FARM 12 - PARKING LOT REVISION

CIVIL SITE PERMIT

1st Review
PRCCP:20241731
Dec 2024

Cecil & Associates comment response
Date: 8/19/2025
By: Roger Cecil

C-07

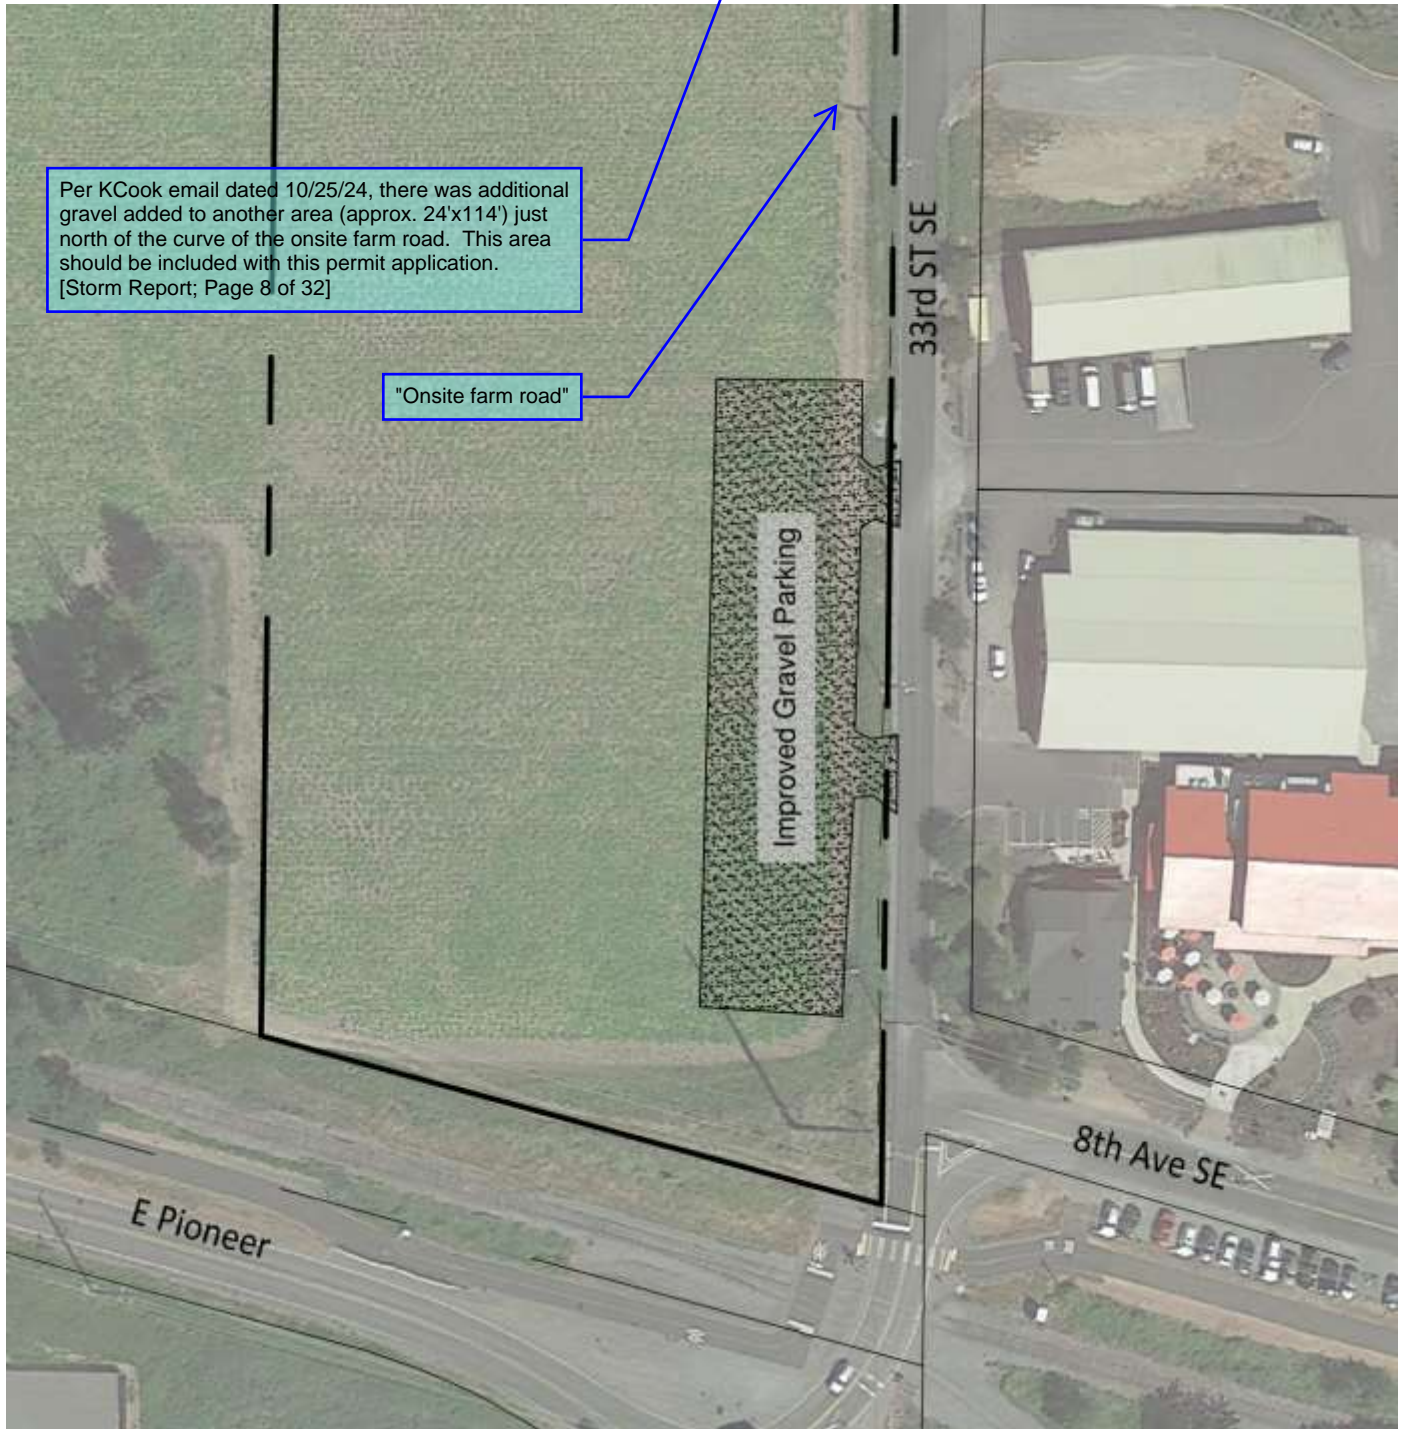
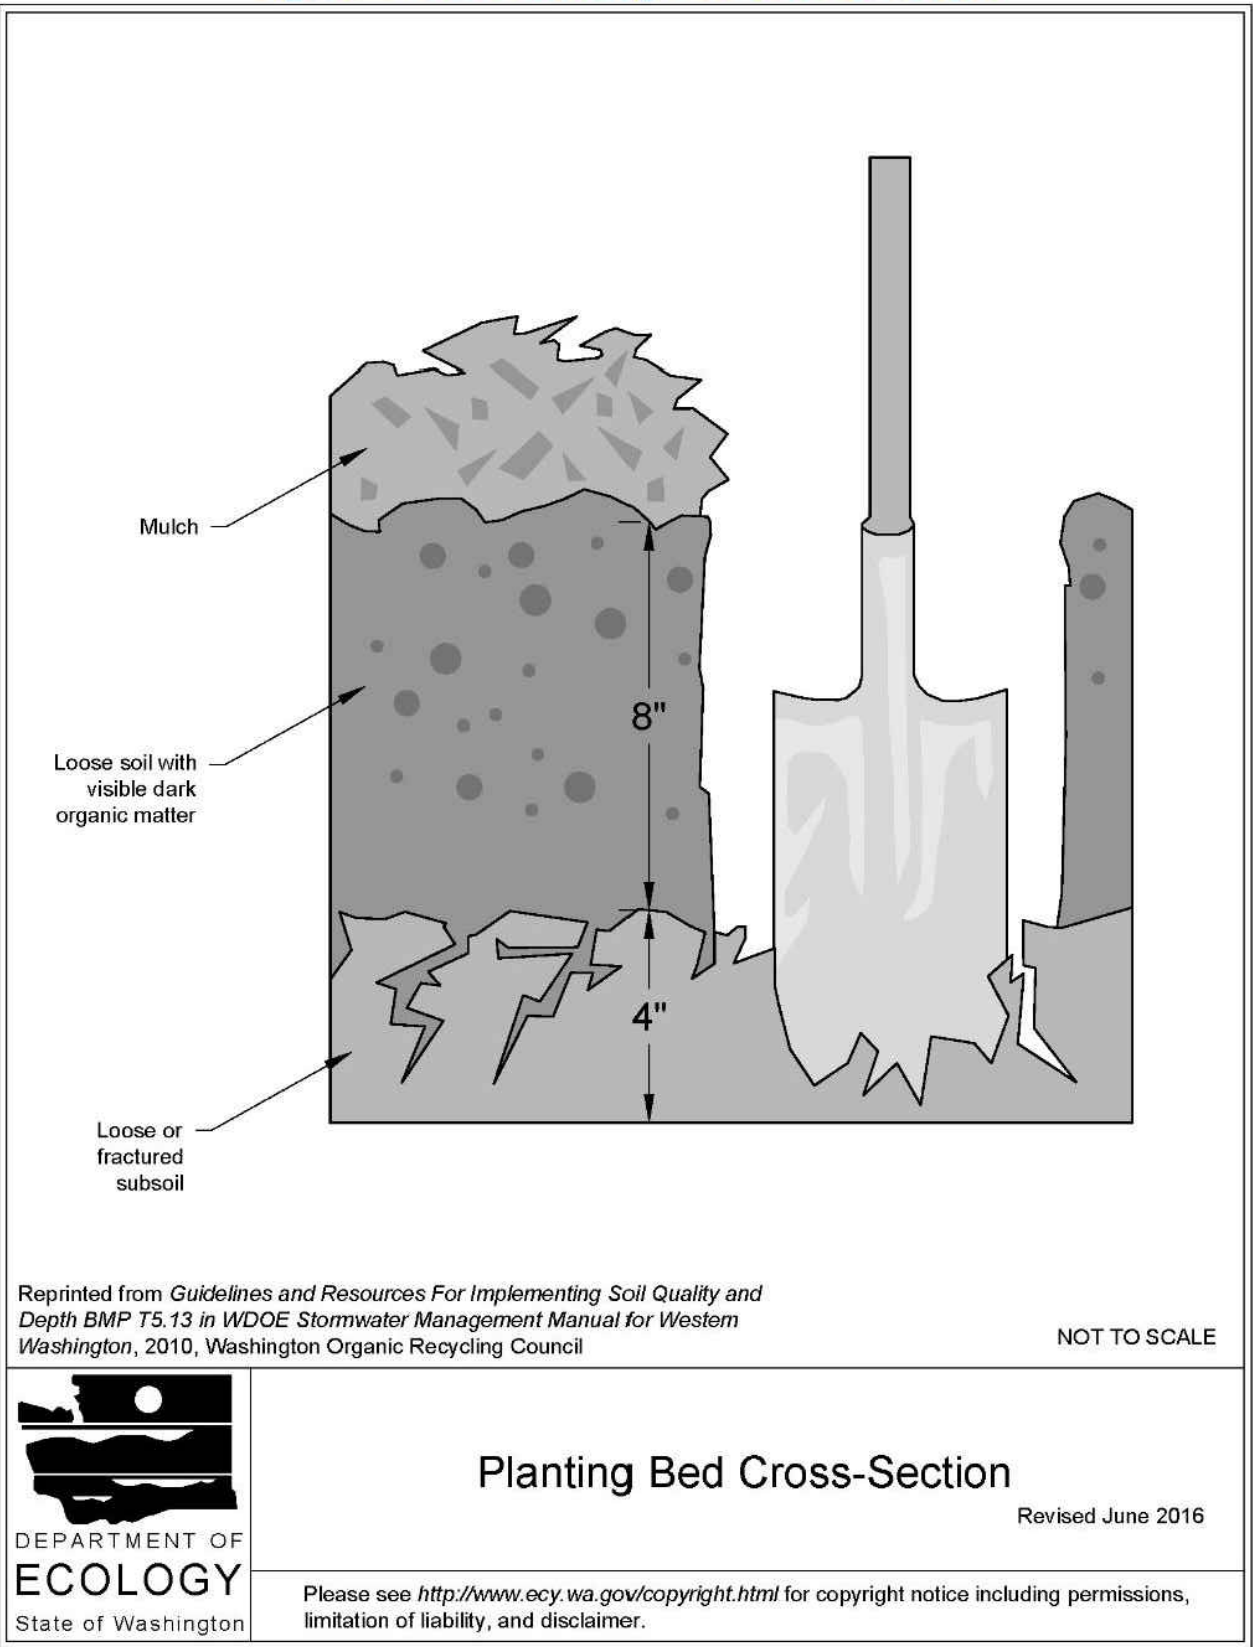
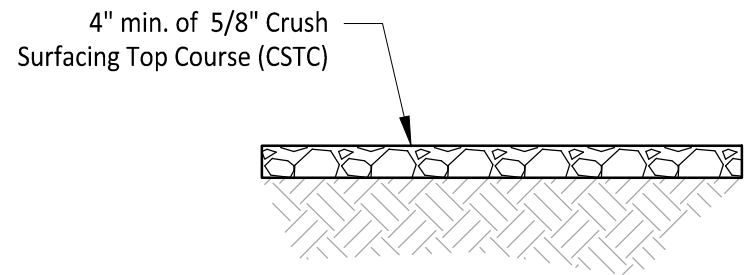
Please revise to: "and City
Standard Detail 01.02.08a."
[Plans: Sheet C-07 of 7]

Add City Standard Detail(s):
01.02.08a. //
[Plans: Sheet C-07 of 7]

REFERENCES TO THE CITY STANDARD DETAIL
HAS BEEN ADDED.

G4.11 WAS ADDED FOR DETAILS
